ADDENDUM NO. 2

RFP #22-53

Valve and Finished Water Tank & Reservoir Improvements

Sheet 7 – WTP River Valve Plans, Sections and Isometric (Reissued, 1 page)

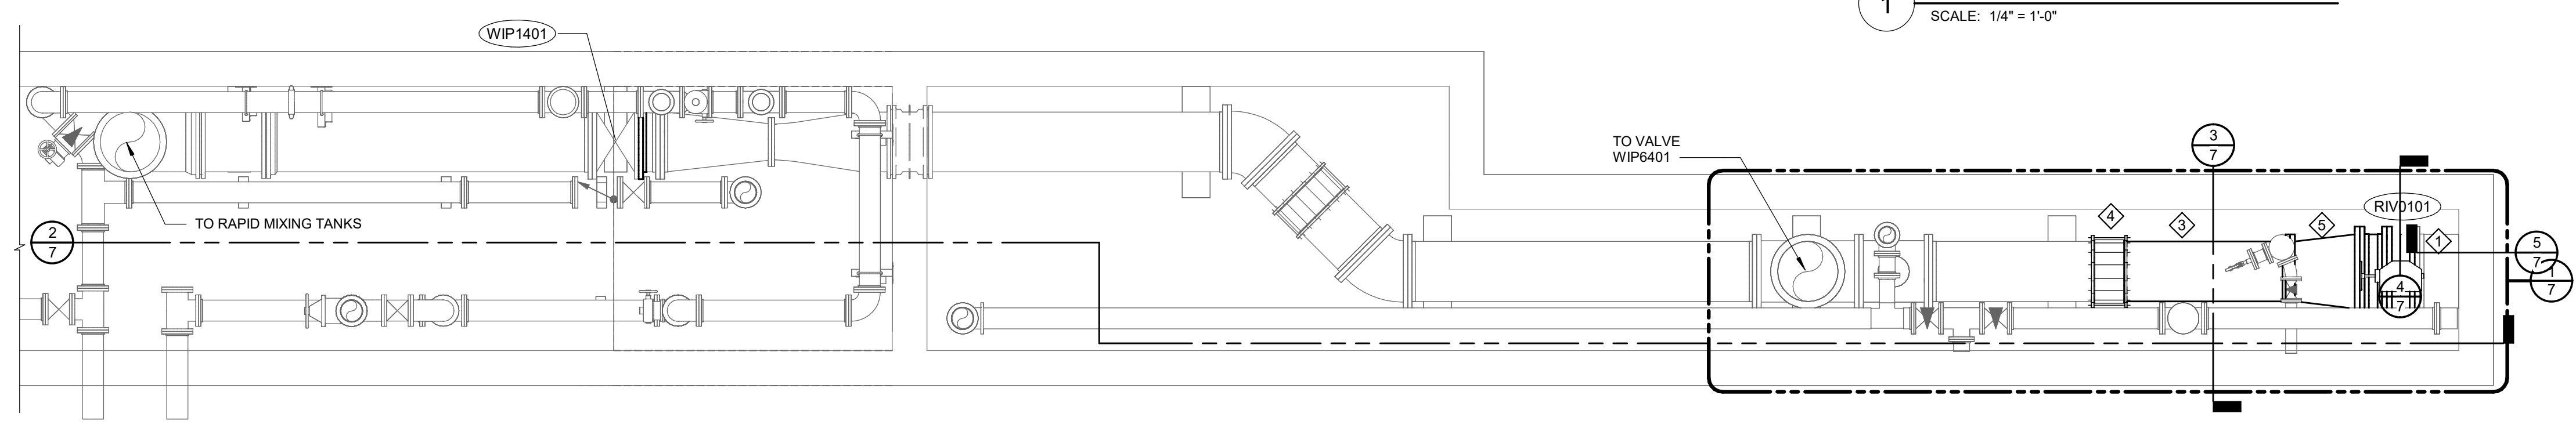
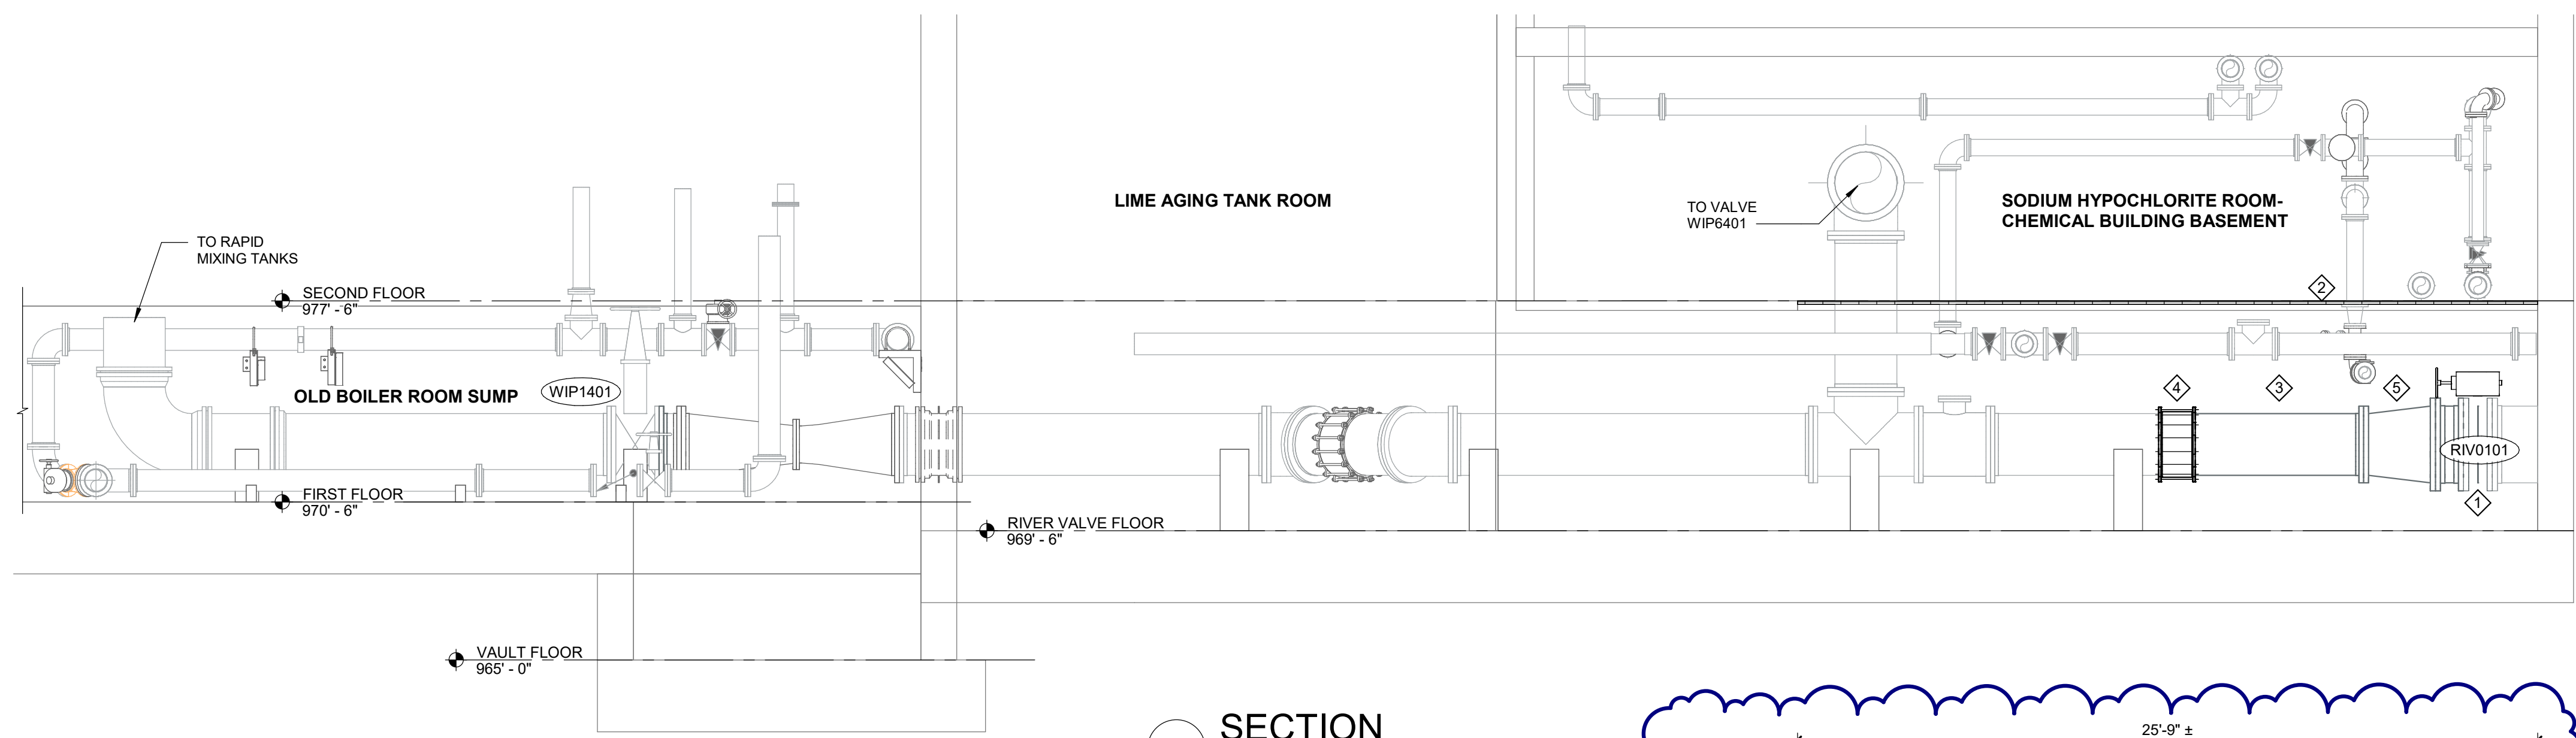
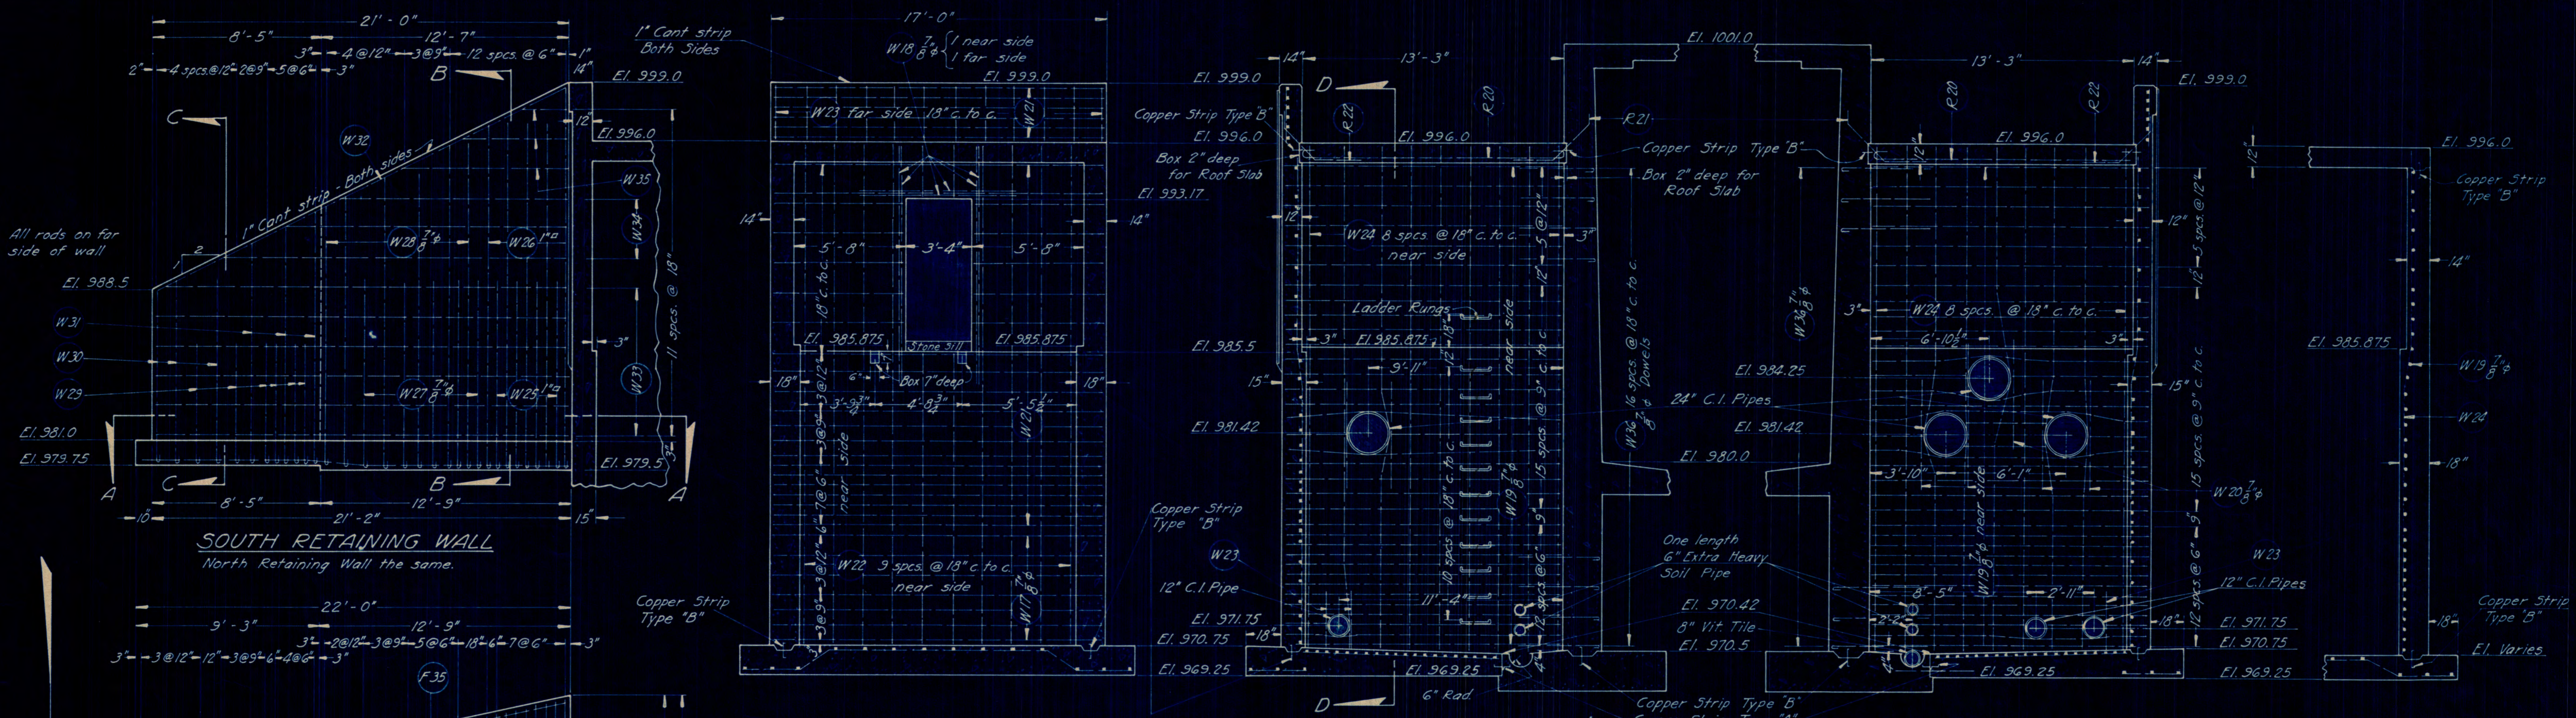
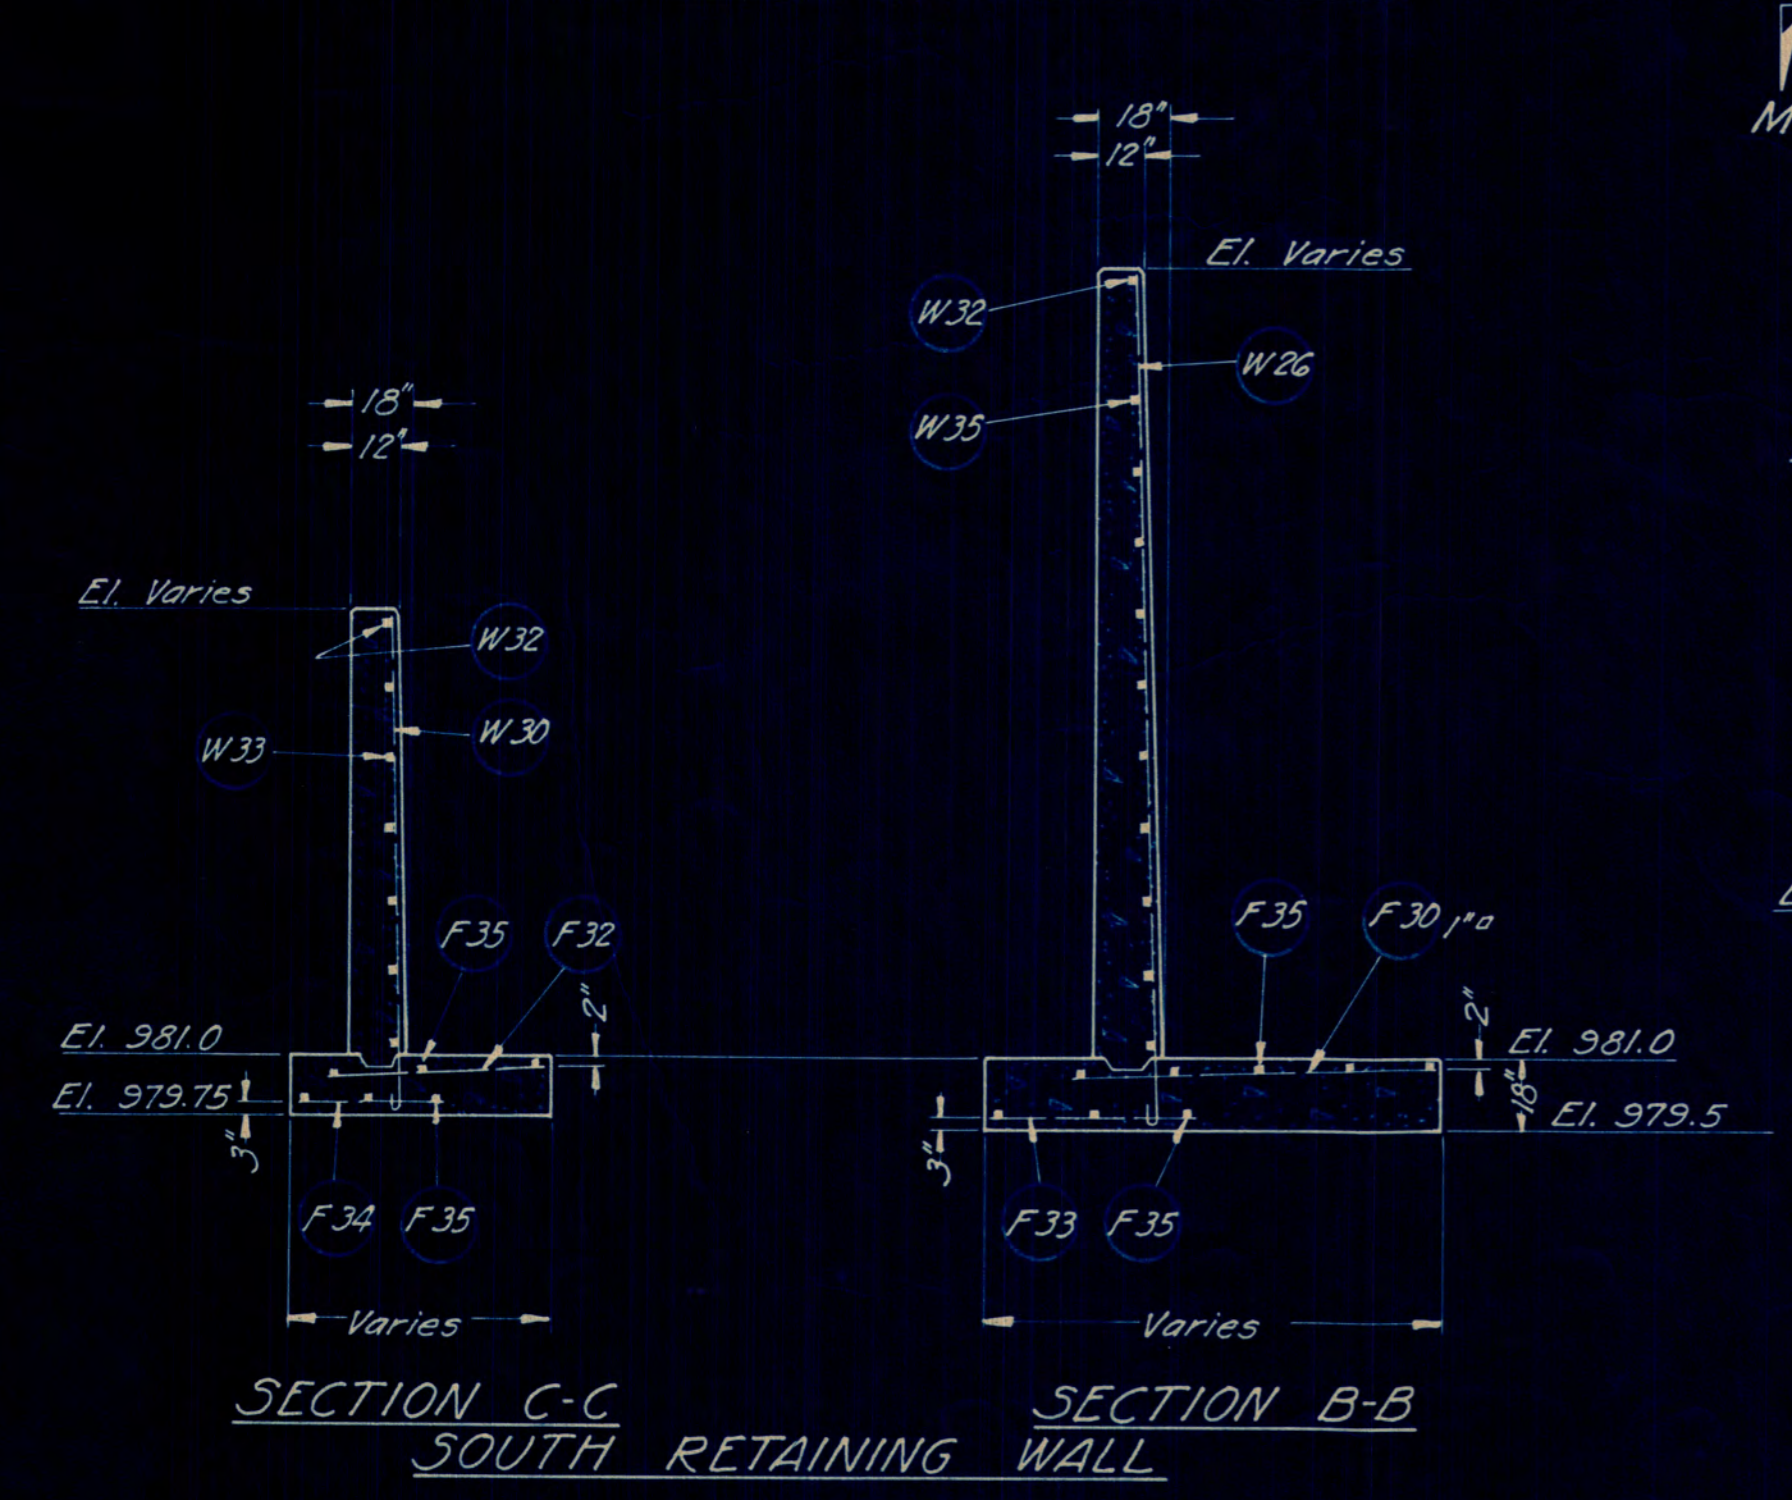
- Q: Note 2 on drawing 7 refers to a detail for the new grating supports but no such detail is provided. Please provide detail.
- A: Details included on reissued sheet 7.

- KEY NOTES**
- 30" BUTTERFLY VALVE.
 - INSTALL PAINTED, GALVANIZED W8X10 GRATING SUPPORTS ACCORDING TO THE DETAIL THIS SHEET AND TO MATCH THE LAYOUT THAT WAS FIELD VERIFIED. INSTALL PAINTED, GALVANIZED W8X10 SUPPORTS AT ENDS OF GRATING AT PENETRATIONS, AND FRAME BACK TO GRATING SUPPORTS SPANNING ACROSS TRENCH. INSTALL PAINTED, GALVANIZED L5X3X1/4 ACCORDING TO THE DETAIL THIS SHEET AT EACH END OF THE TRENCH. ENSURE ENDS OF GRATING SPANS WILL BE SUPPORTED AND THAT GRATING DOES NOT SPAN MORE THAN 4- FEET. INSTALL SALVAGED GRATING ON NEW SUPPORT SYSTEM AND ANCHOR TO SUPPORTS WITH STAINLESS STEEL SADDLE CLIPS IN A CONFIGURATION THAT PERMITS GRATING TO BE REMOVED IN THE FUTURE.
 - 24" PIPING.
 - 24" COUPLING.
 - 30"x24" REDUCER.
